THE GOVERNMENT OF THE REPUBLIC OF MALAWI
MINISTRY OF AGRICULTURE, IRRIGATION AND WATER
DEVELOPMENT
KAPICHIRA DAM AND SHIRE VALLEY IRRIGATION
PROJECT

VISIT REPORT BY PANEL OF EXPERTS

REPORT ON VISIT TO KAPICHIRA DAM

The above described conditions are shown in the photographs in Figures 1 and 2

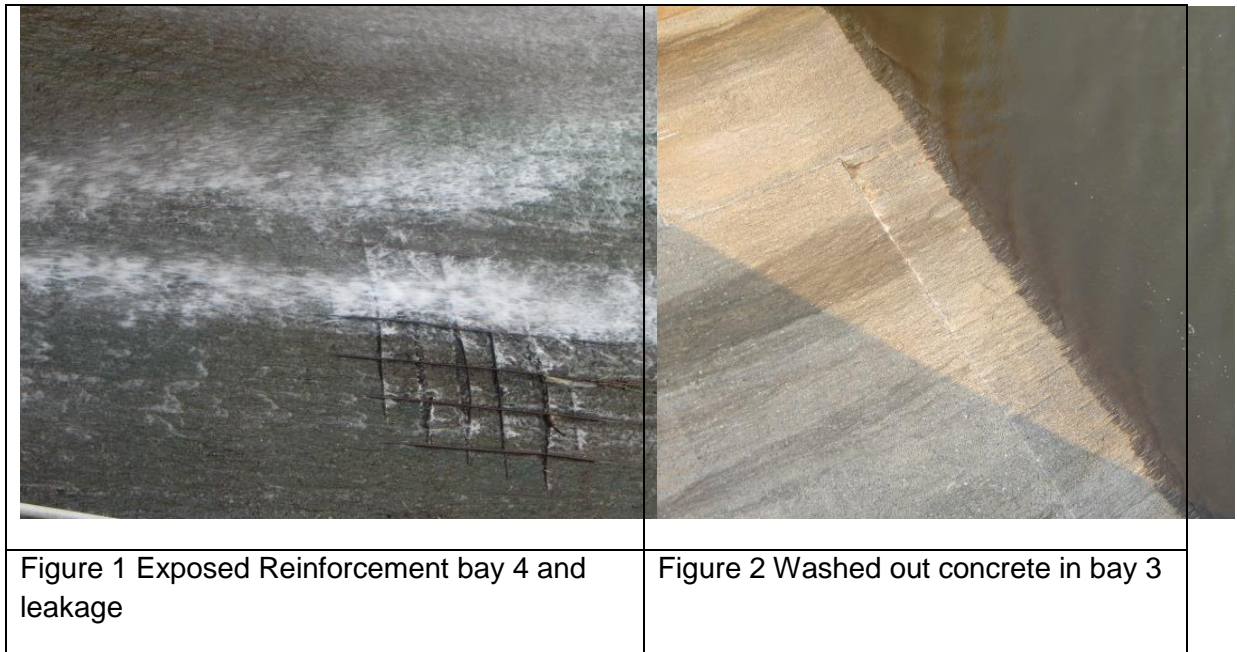
1. The sloping chute of Bay 1 shows normal wear and tear.
2. Cracks are observed on chute of Bay 2.
3. Cracks are observed on Chute of Bay No 3. Some concrete near the toe has been washed away.
4. In Bay No. 4 reinforcement is exposed in one block.
5. The bottom seals of most of the gates are not effective and leakage is taking place.

- The damages on the concrete chute should be repaired as per recommendation of a qualified civil engineer. This should be done within a year of the date of this report.
